UNITED STATES PATENT AND TRADEMARK OFFICE

APPLICATION NO.	FILING DATE	FIRST NAMED INVENTOR	ATTORNEY DOCKET NO.	CONFIRMATION NO.
10/817,383	04/02/2004	Michael E. Gvili	19271-00001	2874

Office Action Summary	Application No. 10/817,383	Applicant(s) GVILI ET AL.	
	Examiner Gary L. Welch	Art Unit 3765

DETAILED ACTION

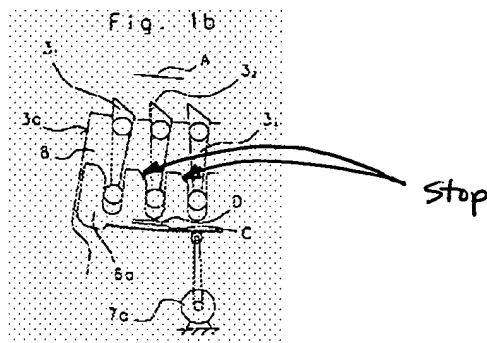
With regard to claims 13 and 27, a movement limiting stop (see figure below) is provided for the grid bar.

With regard to claims 14 and 28, a stop switch is provided for the grid bar thereby preventing over rotation of the grid bar (see figure above).
